DIST	COUNTY	ROUTE	KILOMETER TOTAL PROJECT	POST PROJECT	SHEET No	TOTAL SHEETS
04	SF	80	13.2/13.9		133R2	1204

REQUEST FOR INFORMATION NOT ADDRESSED IN THIS CCO REMAIN IN FORCE					
MARK	DATE	DESCRIPTIONS	REV	CH'D	CCO#
②	02/19/08	ELECTRICAL MODIFICATIONS	MP	RR	42
①	10/16/06	REVISED SHEET NOTES	LR	MG	11

DETAILS
SAS SUPERSTRUCTURE ROADWAY WESTBOUND
CONDUIT LOCATIONS
 SCALE AS NOTED

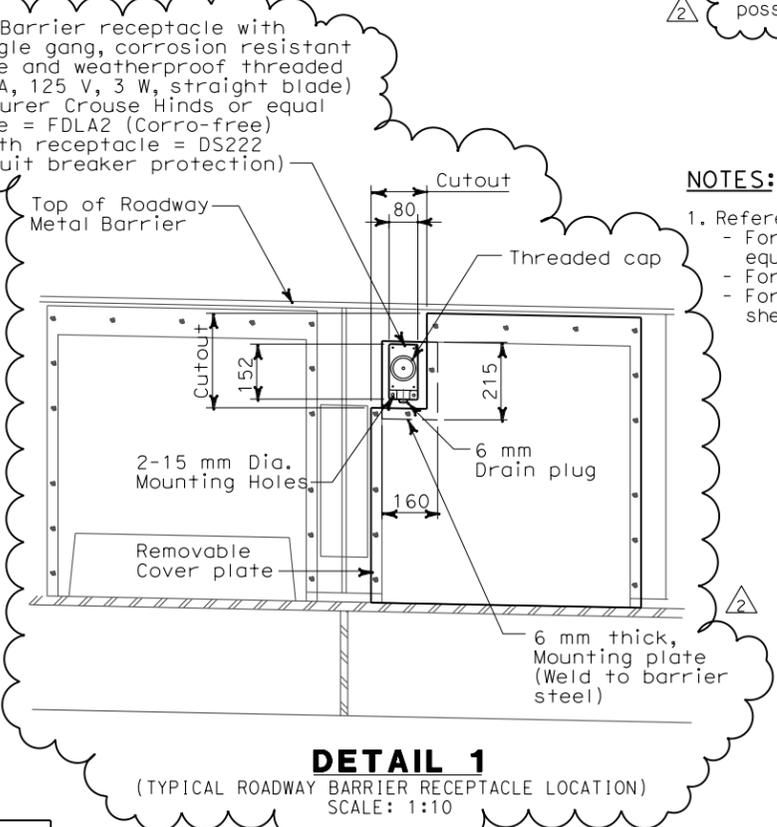
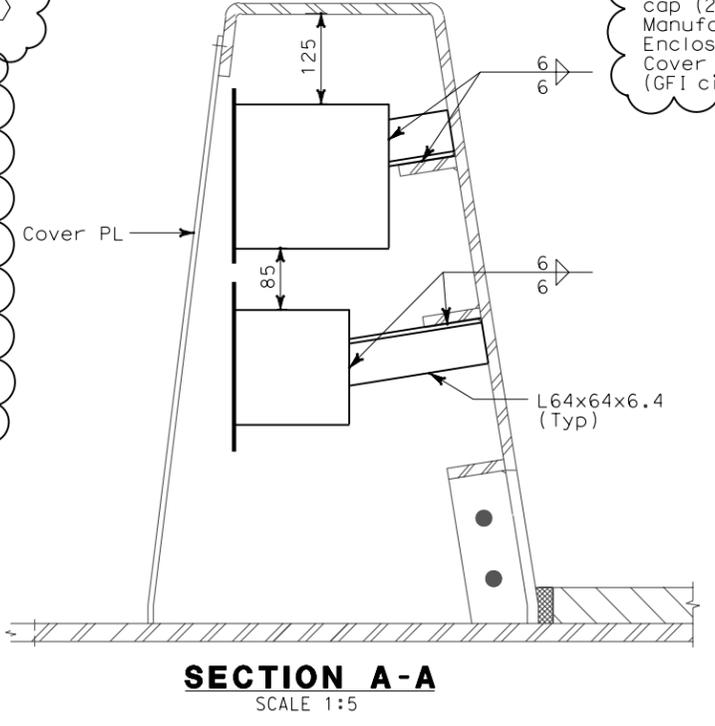
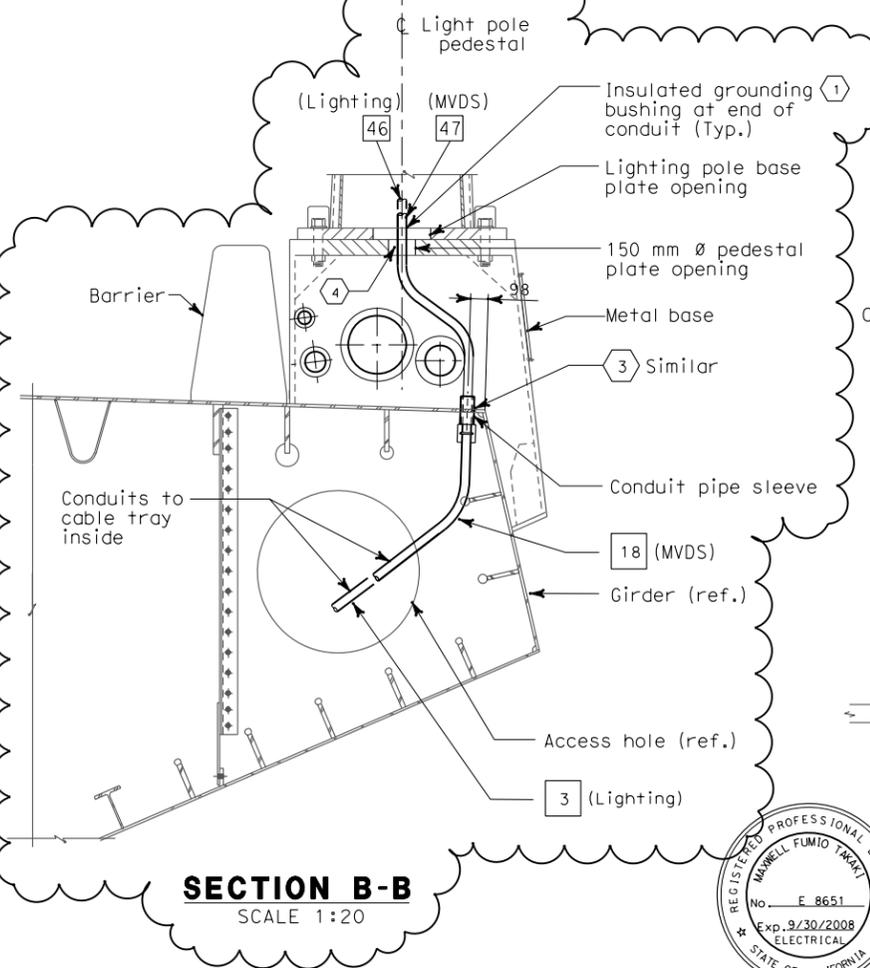
- SHEET NOTES:**
- ① Bond grounding bushing to ground lug of lighting pole or overhead sign post with #6 bare copper wire.
 - ② Deleted
 - ③ See Utility Detail No. 1 (Sheet No. 965 of 1204) for conduit penetration through girder plate and lighting pole metal base. The Contractor shall install sealant between the sleeve and conduit to prevent water or moisture from passing inside the sleeve.
 - ④ Ensure that the maximum of three conduits passing through the 150 mm Ø pedestal plate opening are separated as much as possible from each other.
